SUBJECT: **Safety Tipping Point Overloaded:**
"Sight Distance Study" & Proposed Plat
for "5th Street Bluffs Subdivision"

RE: PROPOSED "5TH STREET

BLUFFS SUBDIVISION"

TO: LDC Metro Planning Commission
RE: Doubts, discrepancies
in 5th Street Bluff

FROM ORIGINAL "GRANDVIEW HEIGHTS" SUBDIVISION PLAT OF RECORD

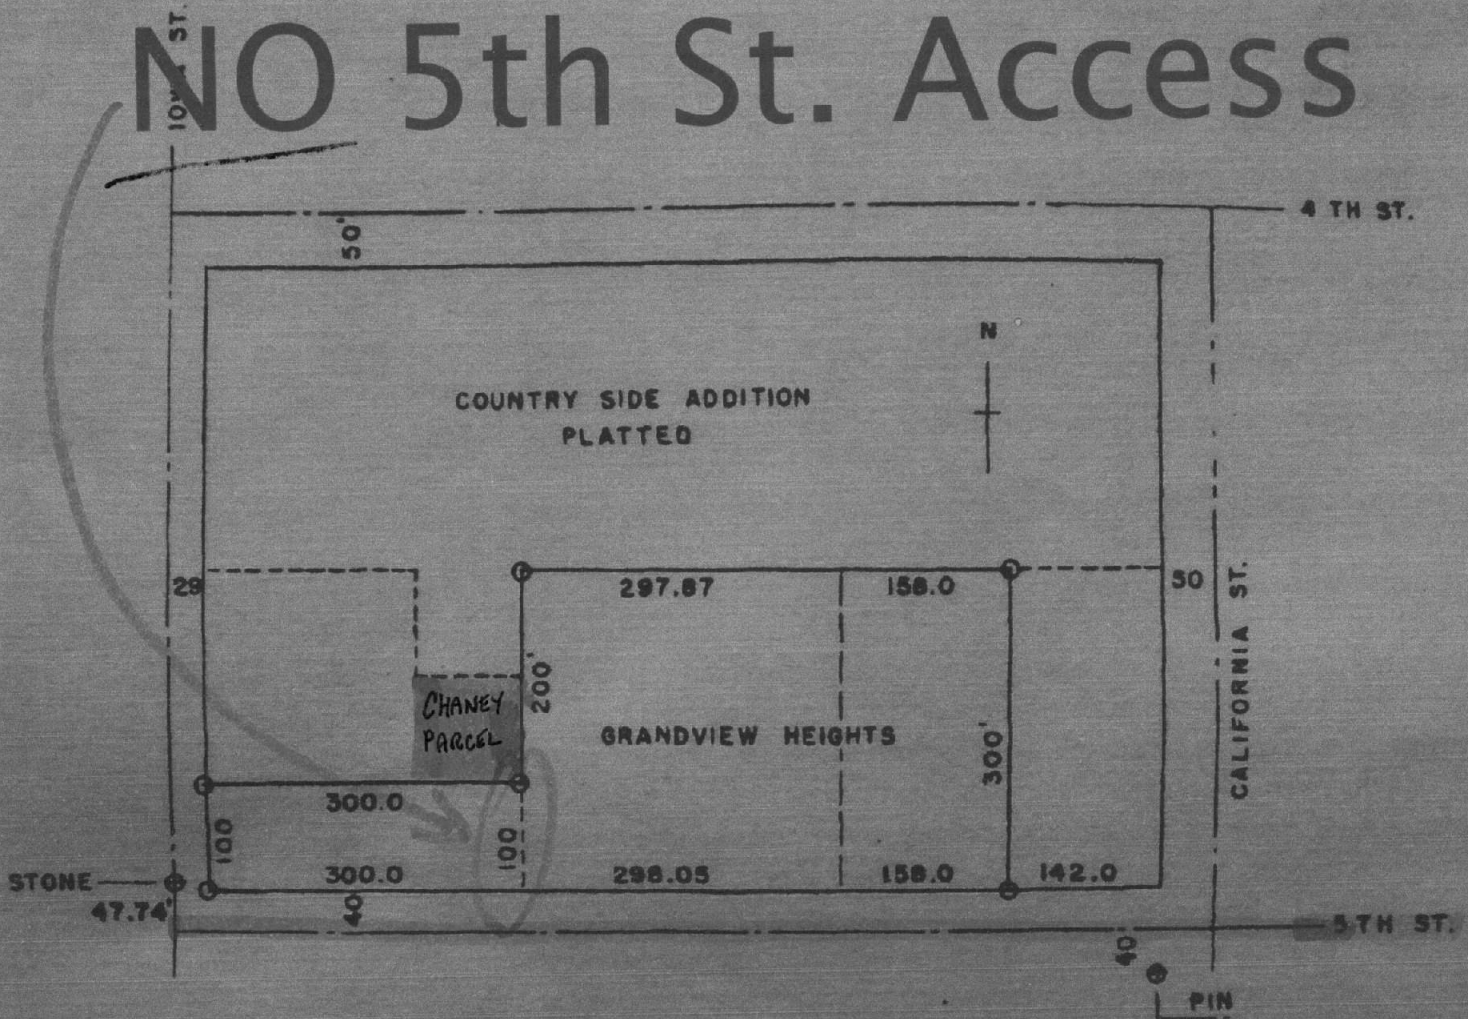
Further: The existing plat for Grandview Heights omits the subject unplatted parcel entirely from its intended neighborhood planning. No stated intent for access is indicated. Indeed, the block-form "PLATE" appearing lower left on that subdivision plat **EXCLUDES** any access point whatsoever to the subject parcel along 5th Street. This suggests that the **exclusion from 5th Street was quite intentional and made visibly explicit by safety-minded, thoughtful planners of the past.**

NO 5th St. Access

FROM ORIGINAL "GRANDVIEW HEIGHTS" SUBDIVISION PLAT OF RECORD

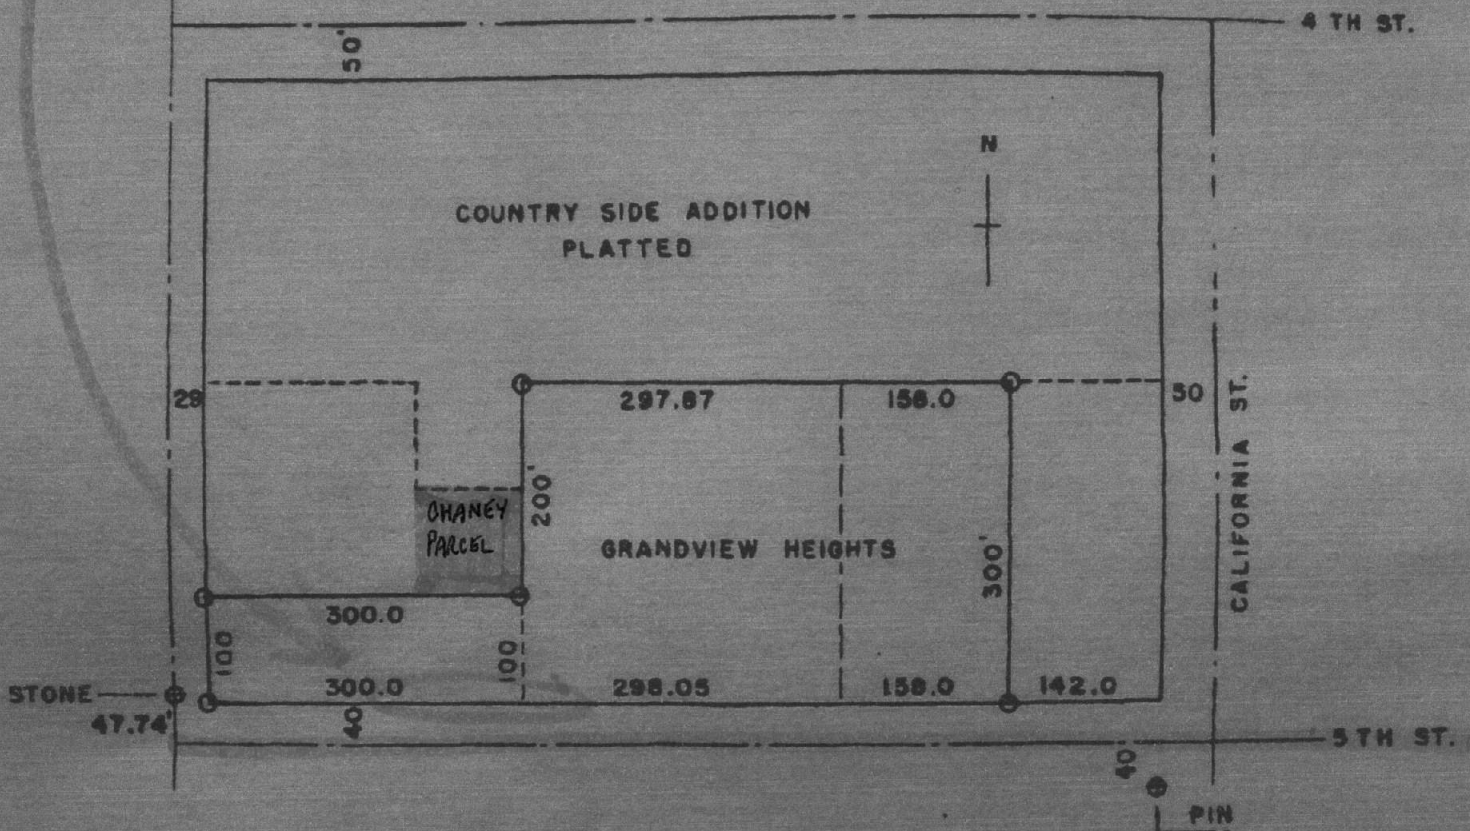
NO 5th St. Frontage
